Proposal for Supplement 17 to the 11 series of amendments to UN Regulation No. 13 (Heavy vehicle braking)

The text reproduced below was prepared by the expert from the European Association of Automotive Suppliers (CLEPA) to include in UN Regulation No. 13 the electro-mechanical braking systems which are state-of-the-art braking systems. The modifications to the existing text of the Regulation are marked in **bold** for new and strikethrough for deleted characters.

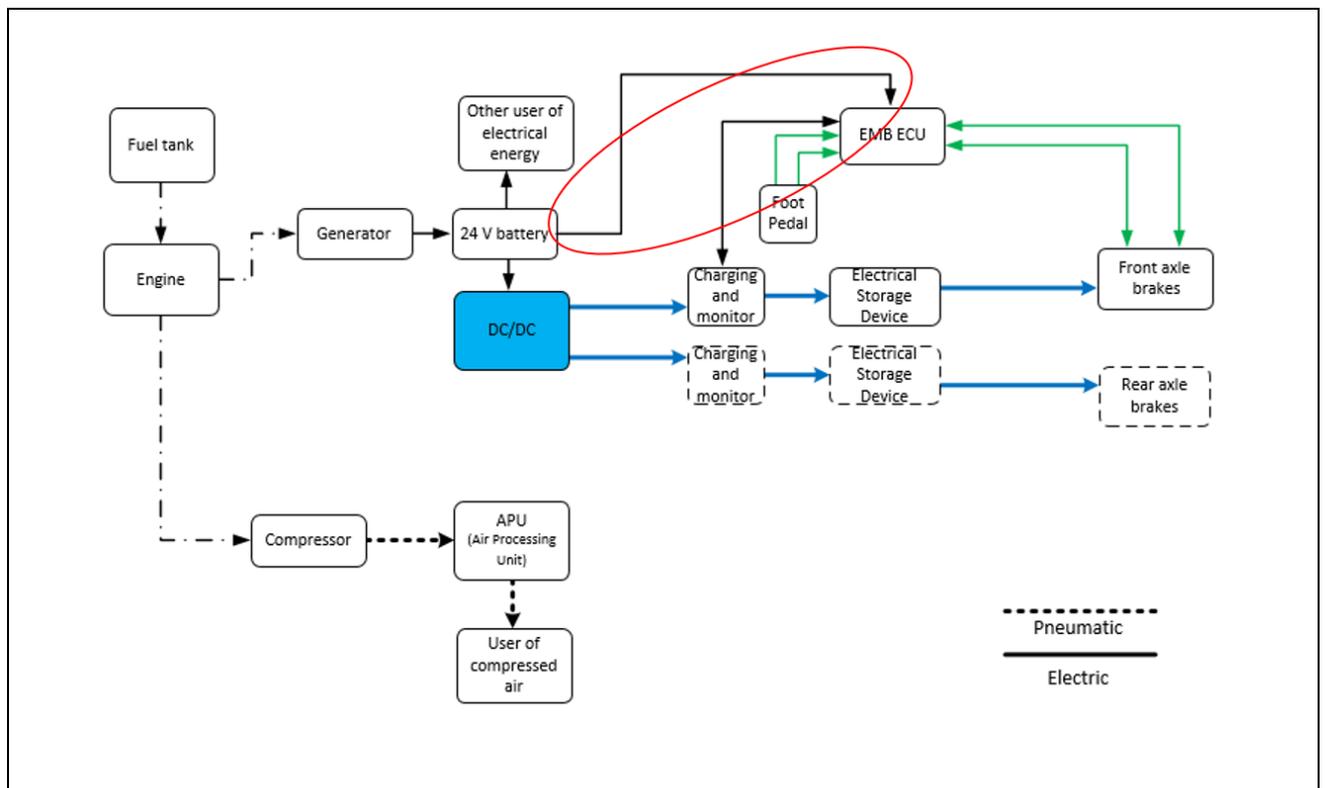
5.2.1.34.5. **With an electrical energy supply feeding only the electric control transmission and in the event of a failure of the energy source of the electric control transmission, starting from the nominal value of the energy level, the full control range of the service braking system shall be guaranteed after twenty consecutive full stroke actuations of the service braking control. During the test, the braking control shall be fully applied for 20 seconds and released for 5 seconds on each actuation. It should be understood that during the above test, sufficient energy is available in the energy transmission to ensure full actuation of the service braking system. This requirement shall not be construed as a departure from the requirements of Annex 7, Part D.**

This requirement is similar to that in paragraph 5.2.1.27.5 but adapted to electro-mechanical braking system. Thus, in the beginning of this paragraph 5.2.1.34.5 the application of this requirement is clarified: "With an electrical energy supply feeding only the electric control transmission and in the event of...". The term "energy source" is replaced by "electrical energy supply" since an "energy source" might not be installed on an electro-mechanical braking system.

*Paragraph 5.2.1.34.5 addresses a configuration of an electro-mechanical braking system where an electrical storage device (e.g. battery) **only** supplies energy to the **control** transmission (but **not** to the electrical energy transmission as this is the case with an EBS which has to comply with paragraph 5.2.1.27.5); as an exemplary braking system see following figure).*

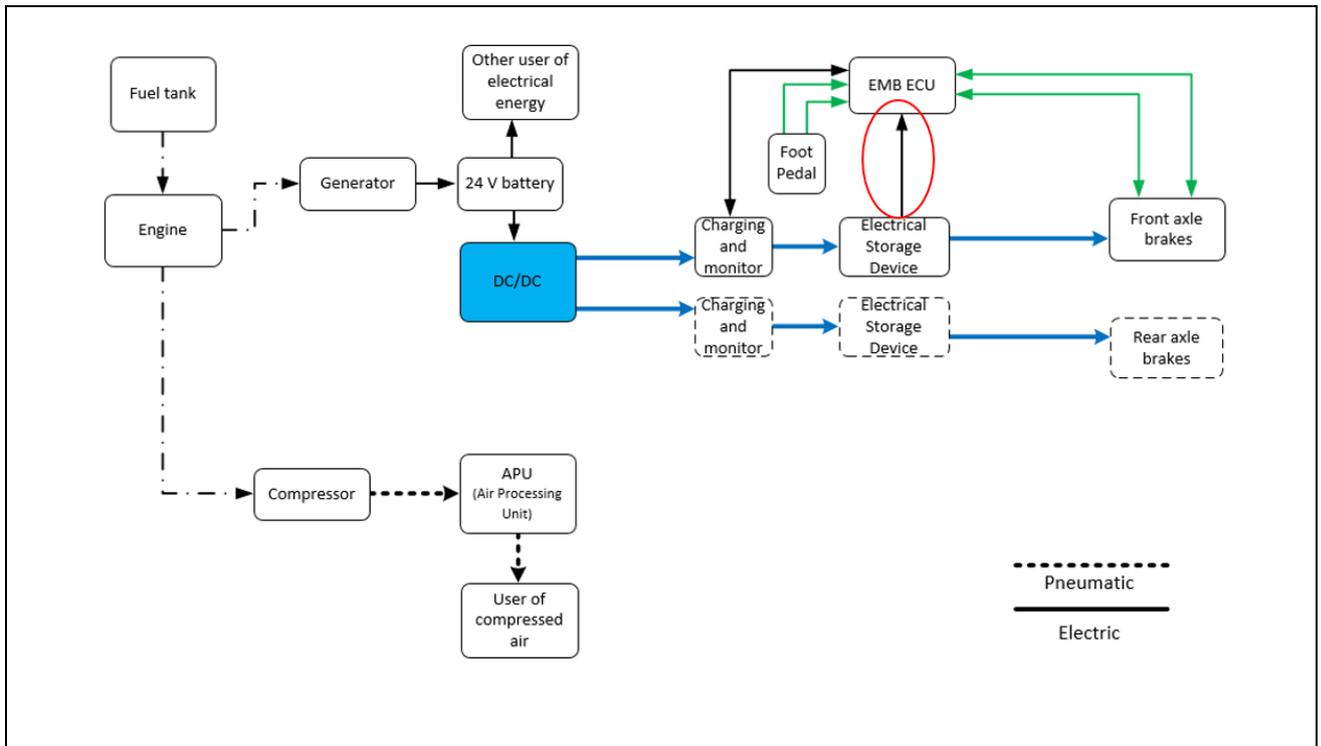
5.2.1.34.6. In the case that the energy storage devices are also providing electrical energy for the electrical control transmission, the requirements of paragraph 1.2.1. of Part D of Annex 7 shall apply.

In contrast to paragraph 5.2.1.34.5, this requirement addresses a configuration of an electro-mechanical braking system where energy storage devices are providing electrical energy for the electrical control and electrical energy transmission; as an exemplary braking system see following figure).

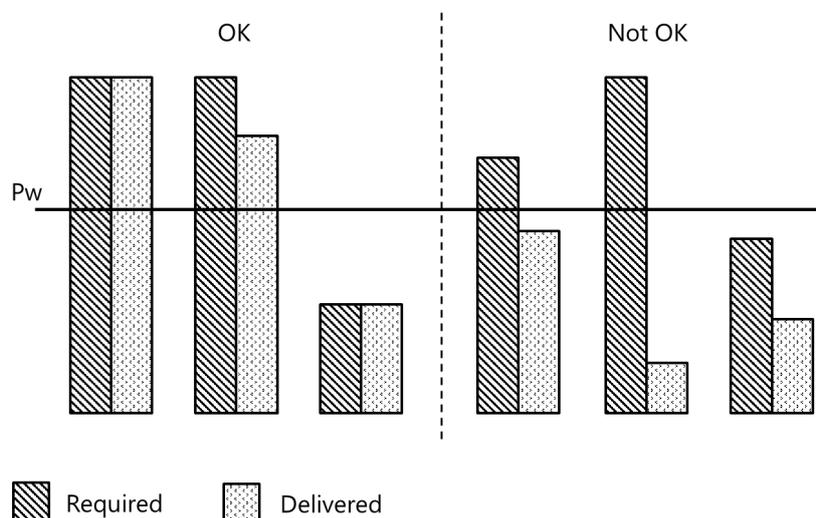
5.2.1.34.7 Any vehicle fitted with a service brake actuated from an energy storage device shall, where the prescribed secondary braking performance cannot be obtained by means of this braking system without the use of the stored energy, be provided with a warning device, giving an optical or acoustic signal when the stored energy, in any part of the system, falls to a value e_w at which without re-charging of the energy storage device and irrespective of the load conditions of the vehicle, it is possible to apply the service brake control a fifth time after four full-stroke actuations and obtain the prescribed secondary braking performance (without faults in the service brake transmission). This warning device shall be directly and permanently connected to the circuit. When the vehicle is running under normal operating conditions and there are no faults in the braking system, as is the case in approval tests for this type, the warning device shall give no signal except

during the time required for charging the energy storage device(s) from the electrical supply device. The red warning signal specified in paragraph 5.2.1.29.1.1. shall be used as the optical warning signal.

Paragraph 5.2.1.34.7 contains all corresponding and appropriate requirements of paragraph 5.2.1.13.1 which are relevant for electro-mechanical braking systems. Requirements which have no meaning or are not appropriate for EMB systems have been removed (see also Justification as to paragraph 5.2.1.13.2) or have been adapted.
